Robert Poole Building #056
Additions and Renovations
April 28, 2016

ADDENDUM NO. 4

CAM CONSTRUCTION – General Notes and Clarifications

Baltimore City Public Schools
Additions & Renovations at Robert Poole Building #056
1300 W 36TH ST., BALTIMORE, MD 21211

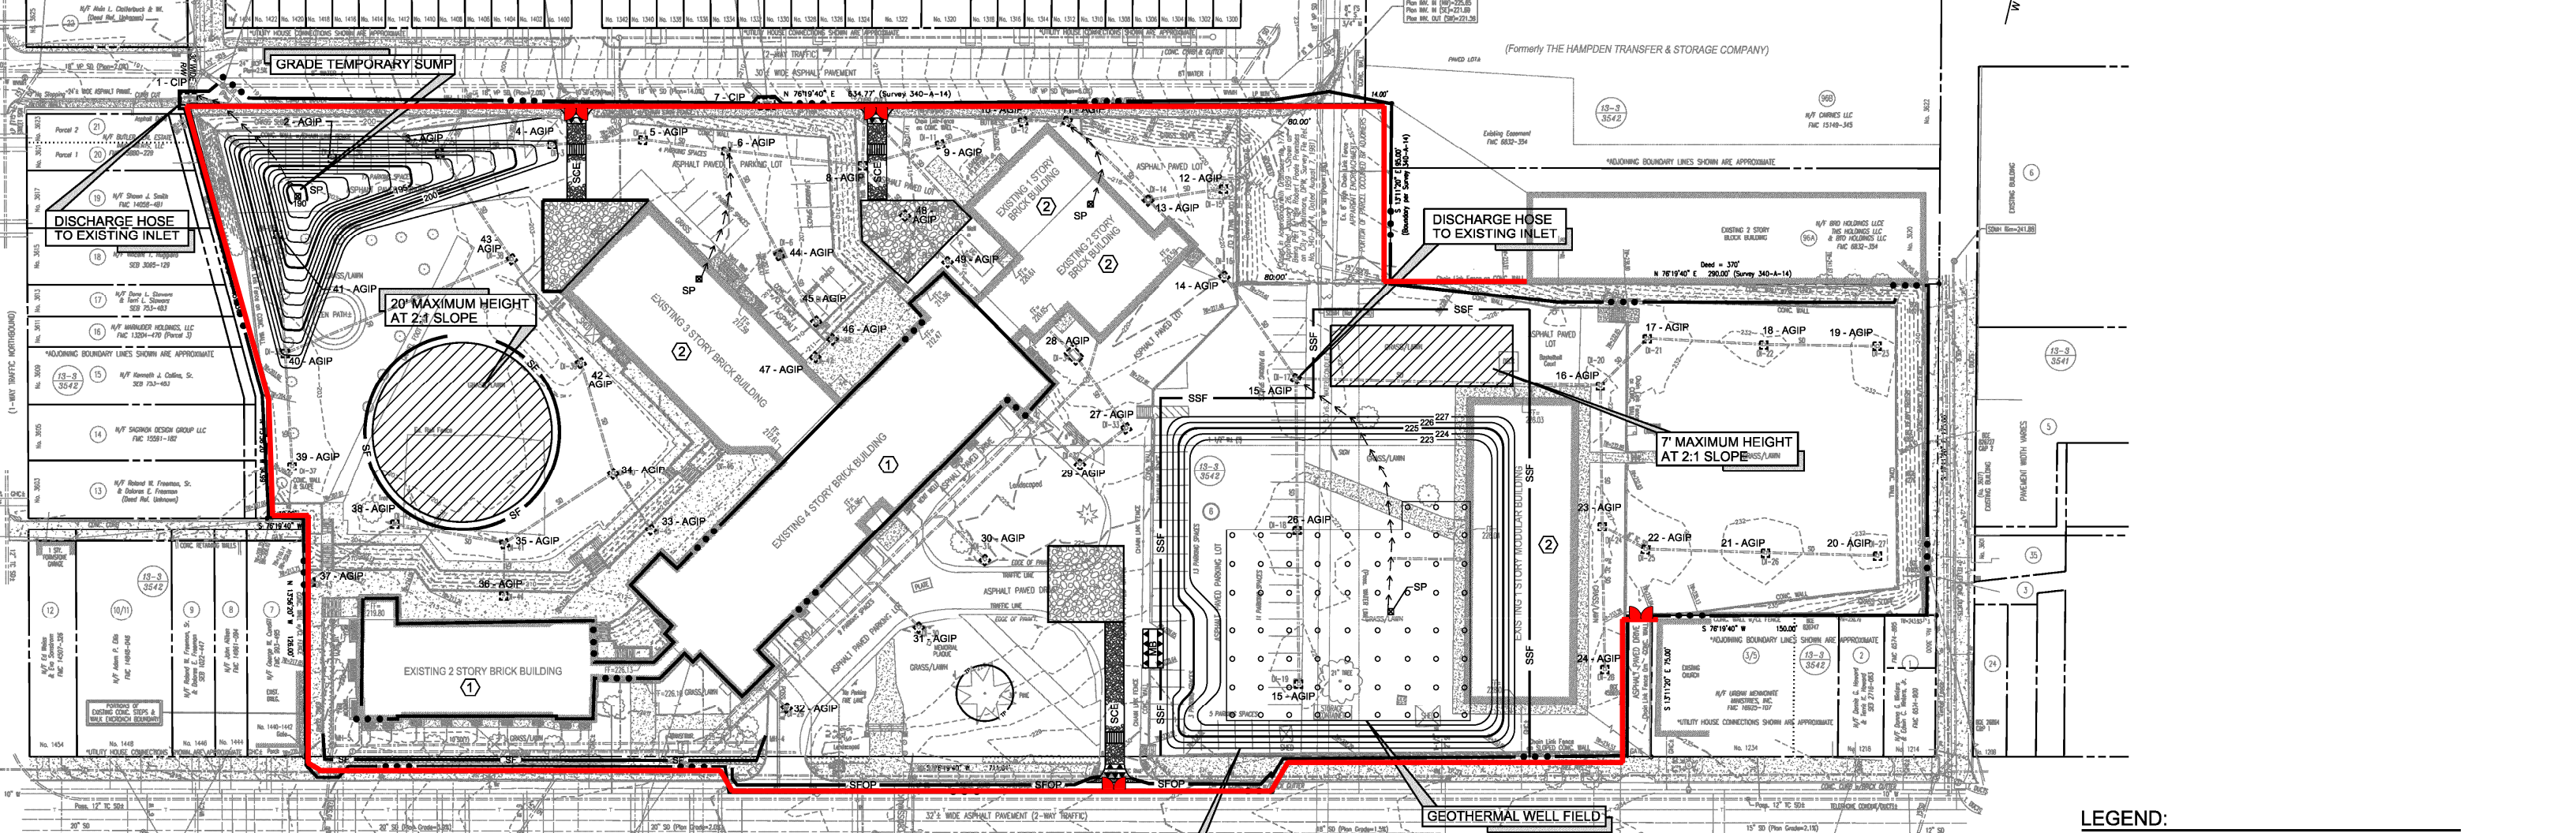
16. Revision to Spec Section 012100 Allowances, page 3, paragraph 3.3.B–Allowance No. 2. Change to read: “Include 4,000 sf of repointing...”.
 17. Fencing Bid Package (32C) - bidders shall include installing and removing a 6’ driven-post chain link fence (no barbed wire) and four (4) sets of gates, to be used as a temporary construction fence for the duration of the project. See the attached highlighted Site Plan (C-1.40), Sketch A4-SK2, reflecting the location of temporary fence and gates.

DRAWING NO.:
AAD 3.01
SCALE: 1/4" = 1'-0"

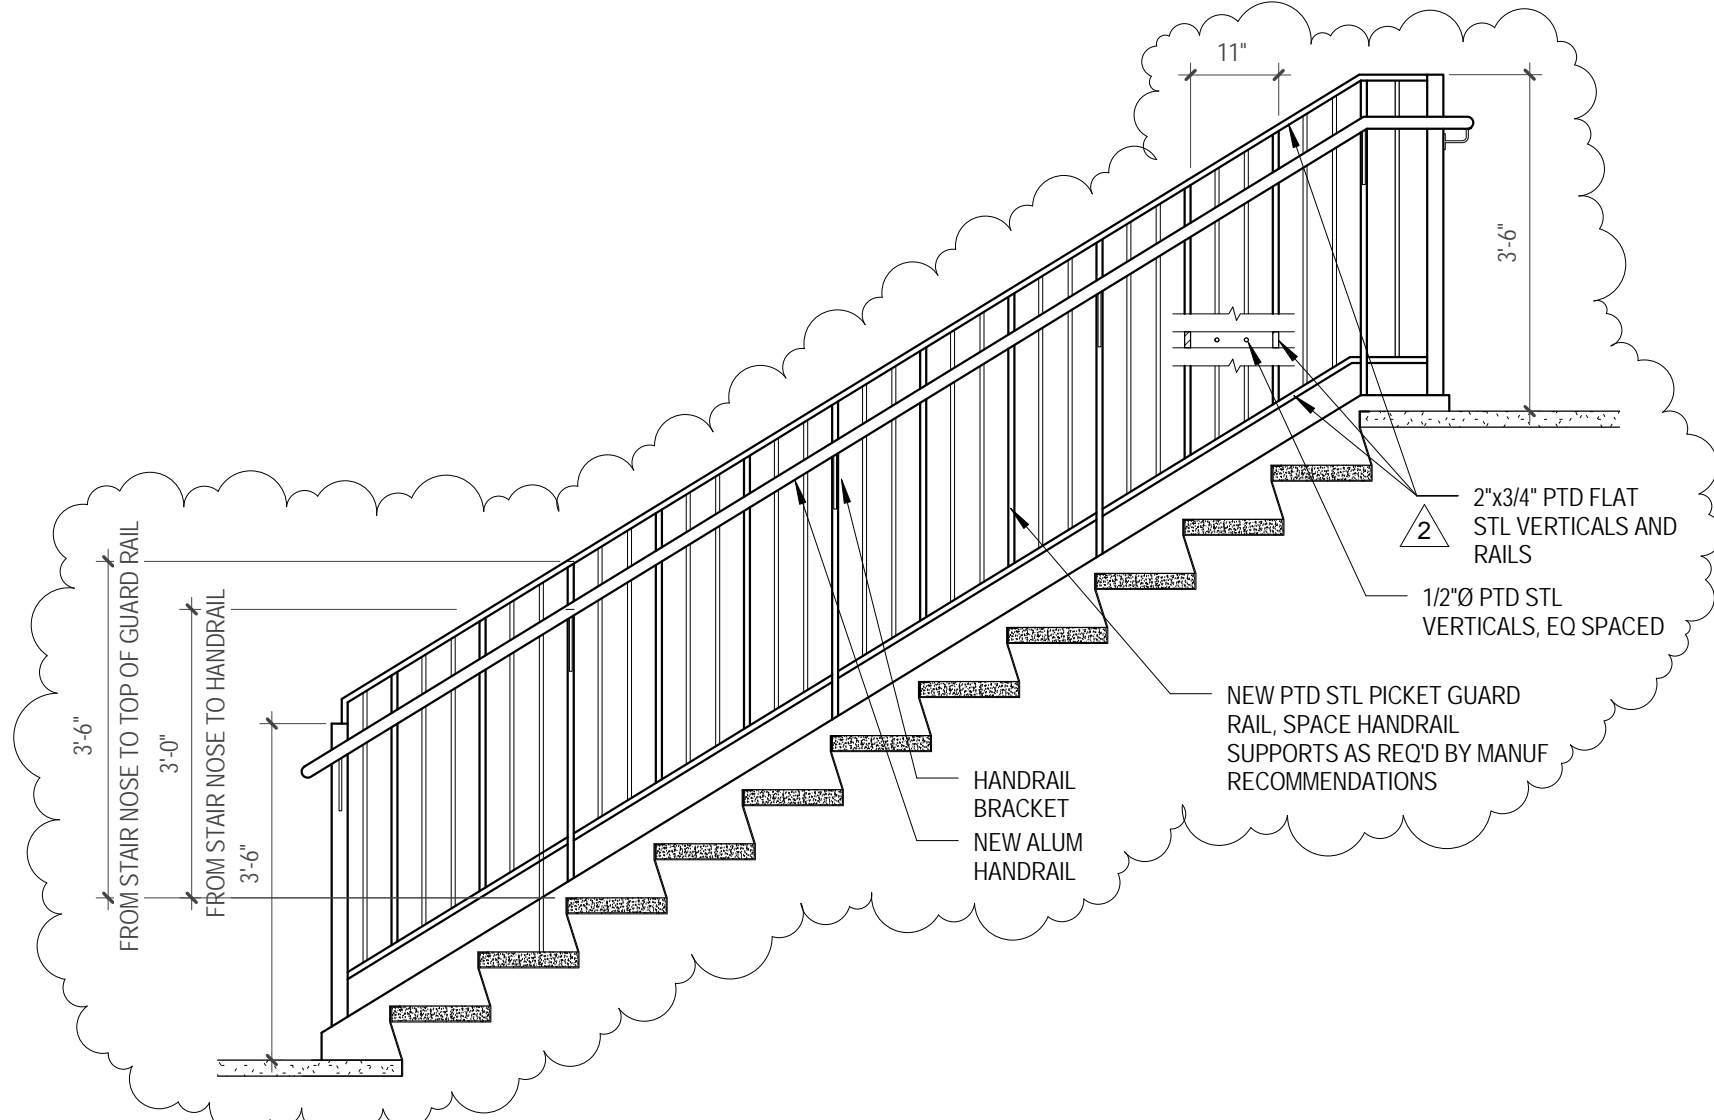
Drawing	Location	Change
A 440	Casework Notes	At Note 1, ADD: "Art room casework is as specified in 123553.19 Wood Laboratory Casework."
A 440	Casework Notes	ADD: "5. Designations C2434, LC2434, and similar tags call out countertops. Countertop material is epoxy resin at all Science Rooms and Art Rooms and plastic laminate at all other locations unless noted otherwise."
A 502	11	REVISE Drawing as shown on the attached sketch AAD 3.02.
A 511	1	ADD: Benches as shown on the attached sketch AAD 3.01
A 511	2	ADD Note: "Benches similar to Greenhouse 1".

**NEW WORK BASEMENT &
FIRST FLOOR
PLAN A -
PLUMBING**

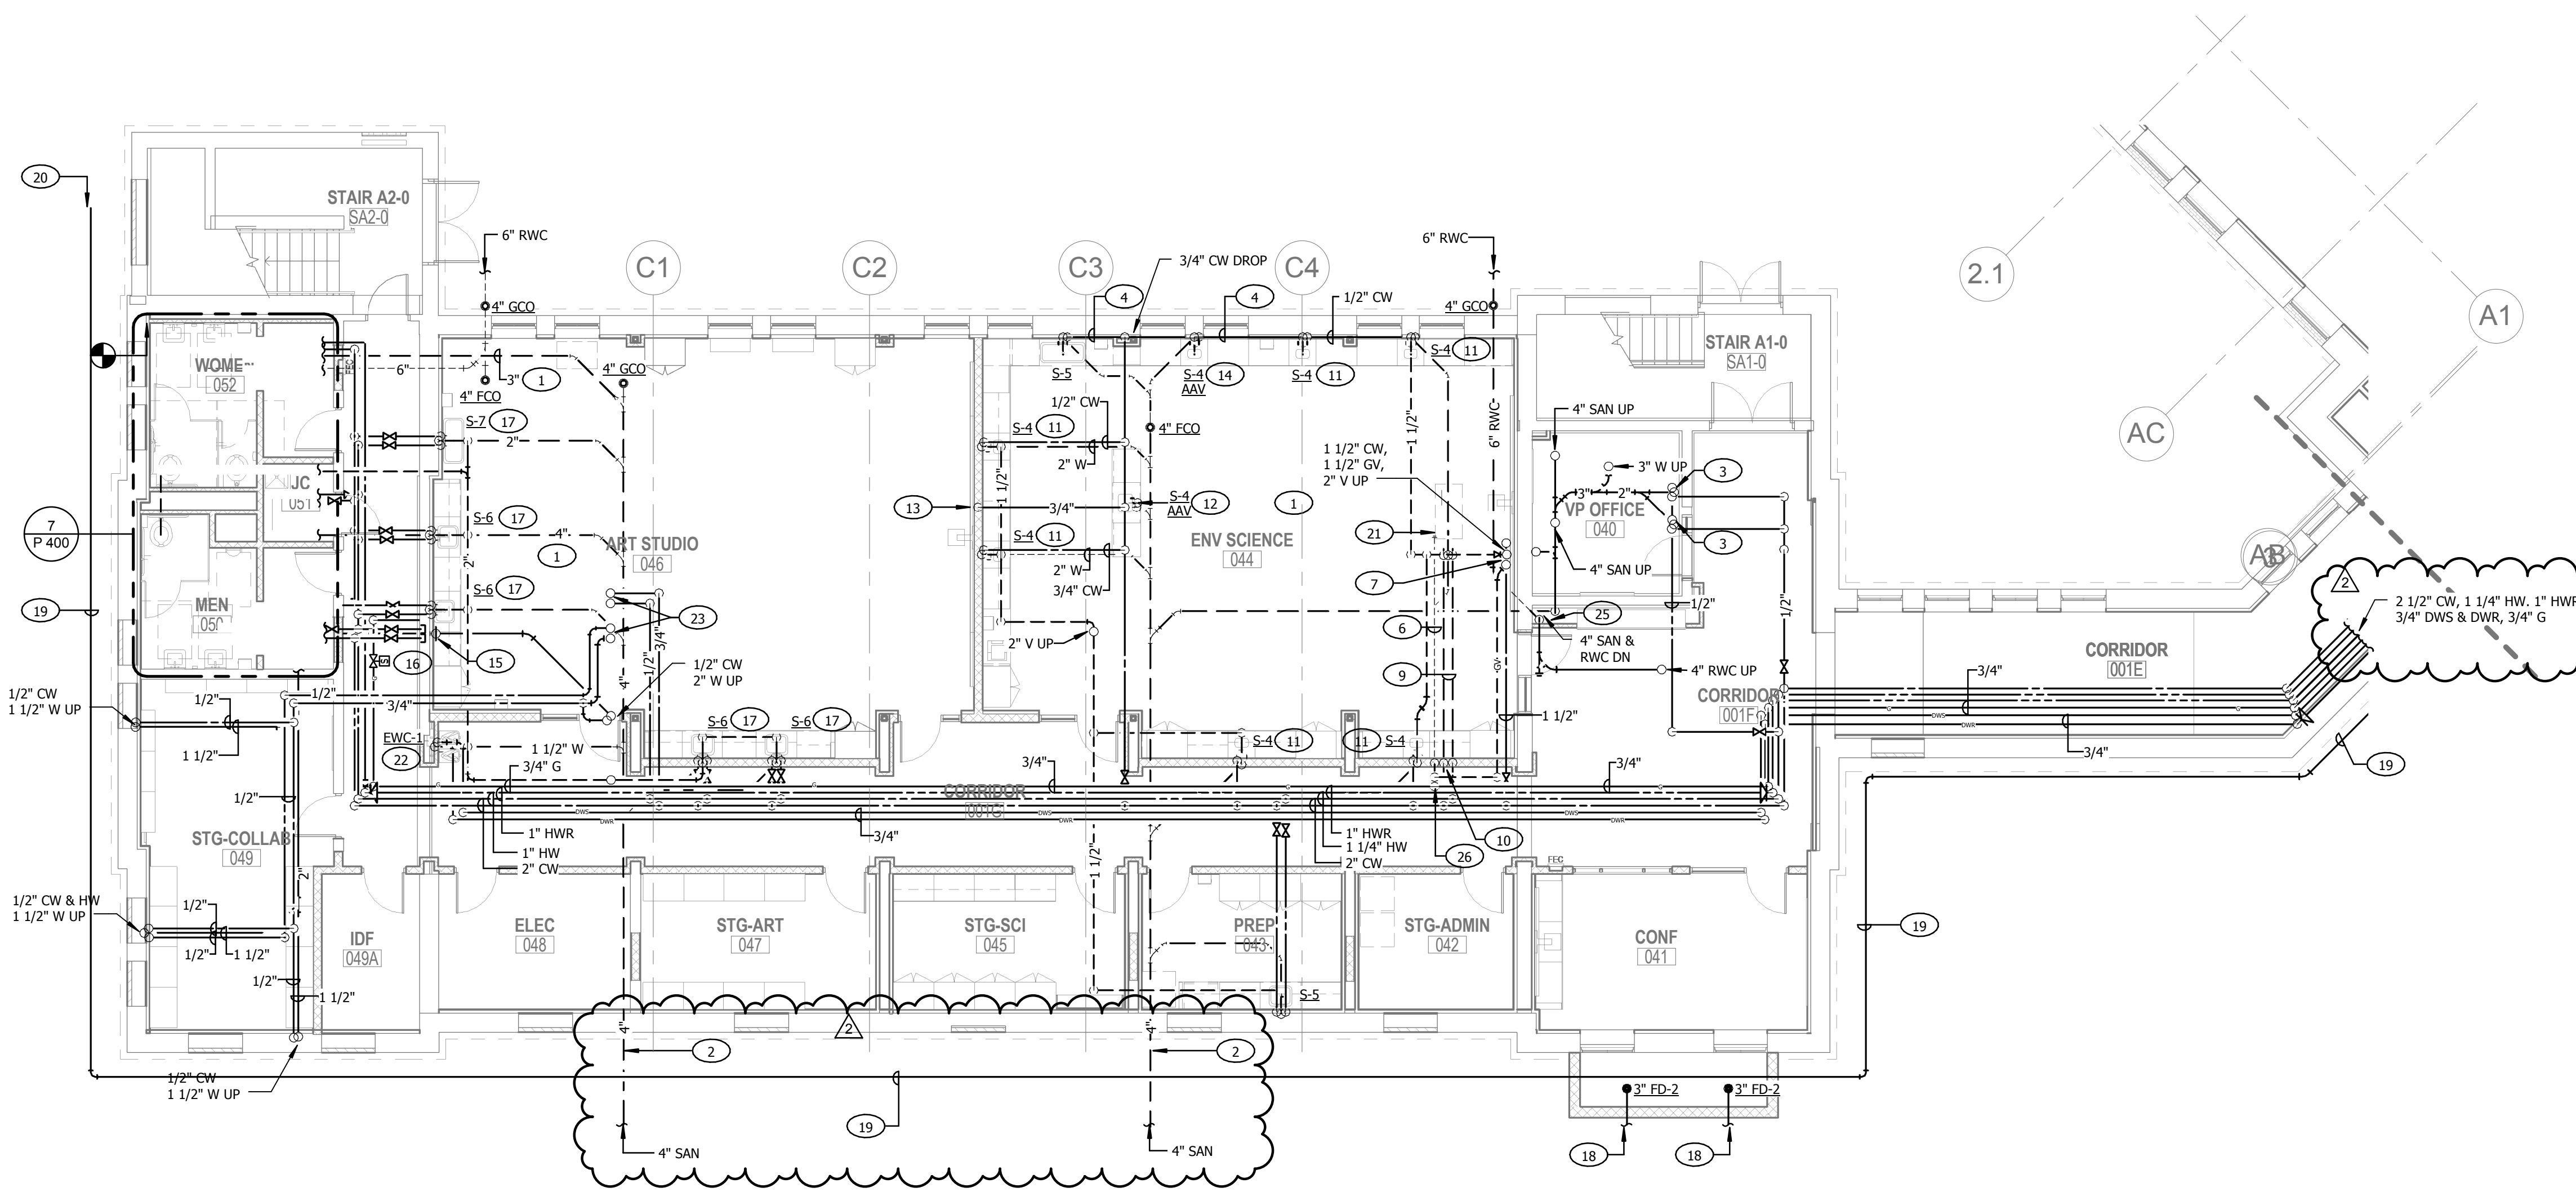
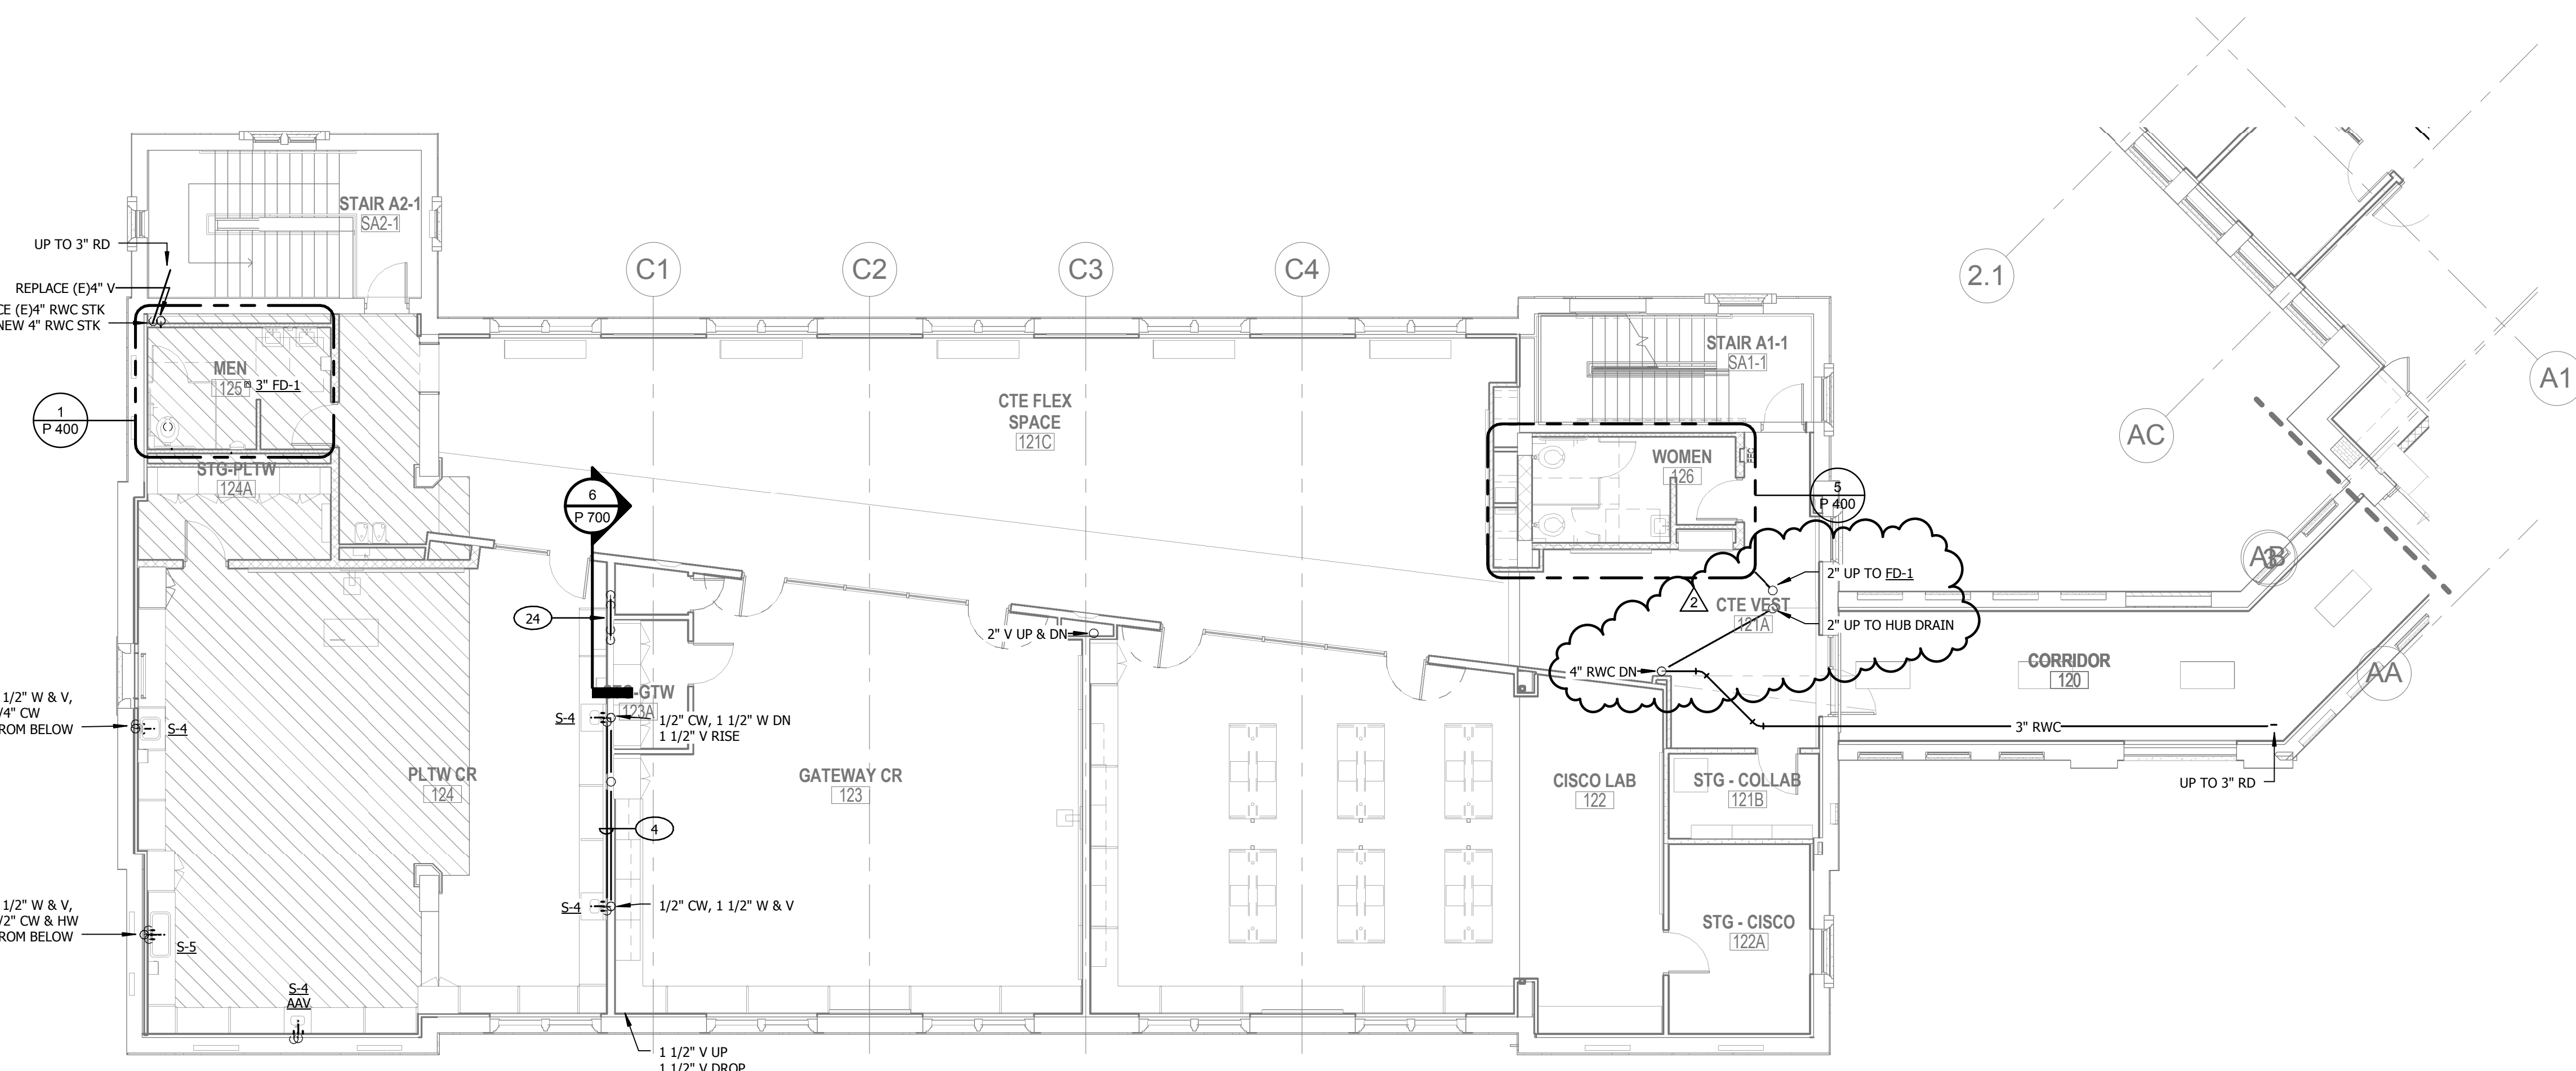
- KEYED NOTES:**
- 1 REPLACE EXISTING UNDER FLOOR SANITARY WITH NEW SANITARY PIPING. FIELD VERIFY EXACT ROUTE.
 - 2 NEW 4" SANITARY TO REPLACE EXISTING 5" SANITARY. FIELD VERIFY EXACT LOCATION.

- 3 1/2" HOT WATER, 1/2" WASTE UP.
 - 4 1/2" COLD WATER, 1/2" WASTE THROUGH CASEWORK FOR SINKS.
 - 5 1/2" COLD WATER, 2" WASTE THROUGH CASEWORK FOR SINKS.

- 6 1/2" CORRUGATED STAINLESS STEEL GAS IN 3" PVC SLEEVE BELOW FLOOR TO INSTRUCTOR TABLE. SEE DETAIL 6/P 700.
 - 7 1 1/2" GAS VENT UP FROM 3" PVC SLEEVE.

- 8 1 1/2" GAS VENT UP AND DOWN.
 - 9 1/2" COLD AND HOT WATER BELOW FLOOR TO INSTRUCTOR TABLE.
 - 10 1/2" COLD AND HOT WATER DOWN. 1/2" CORRUGATED STAINLESS STEEL GAS IN 3" PVC SLEEVE DOWN. SEE DETAIL 6/P 700.

- 21 1/2" DRINKING WATER, 1 1/2" WASTE AND VENT TO WATER COOLER.
 - 22 3/4" COLD WATER AND 1/2" HOT WATER UP TO SHUT OFF BOX IN PLTW CR 124.
 - 23 3/4" COLD AND 1/2" HOT WATER SHUT OFF VALVES IN BOX RECESSED IN WALL. SEE DETAIL 6/P 700.

- 24 FIXED AIR GAP ON RAINWATER STACK FOR AIR CONDITIONING CONDENSATE. SEE DETAIL 10/P 700.
 - 25 PROVIDE SOLENOID VALVE IN GAS LINE TO CLASSROOM FOR EMERGENCY SHUT OFF.
